C57.104 – IEEE Guide for the Interpretation of Gases Generated in Oil – Immersed Transformers

Tuesday, March 26, 2019

Minutes of WG Meeting

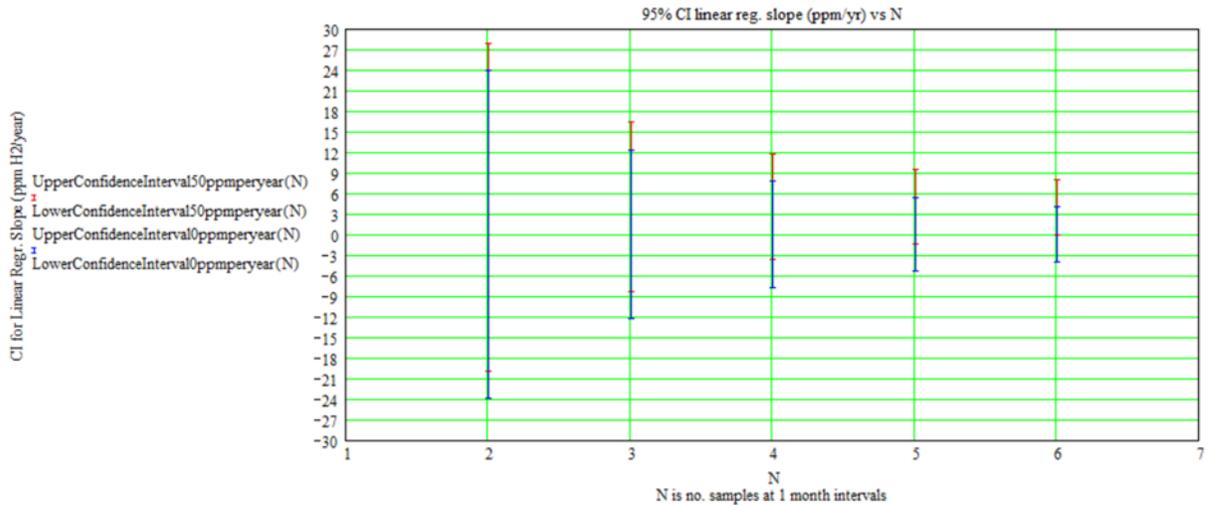
Furthermore analysis of linear regression for 3 to 6 samples, using the ASTM D3612 method precision statements and table 4 values (ppm/year), shows that confidence intervals overlap for no change and 50 ppm/year change. Figure one, for H₂ for example, shows that the 95 % confidence intervals for linear regression of 2 to 6 samples (1 to 5 sample intervals of one month each). This overlap demonstrates that even with linear regression the rates in table 4 cannot be distinguished from the false rates due to the method variations for each sample test result used in the linear regression.
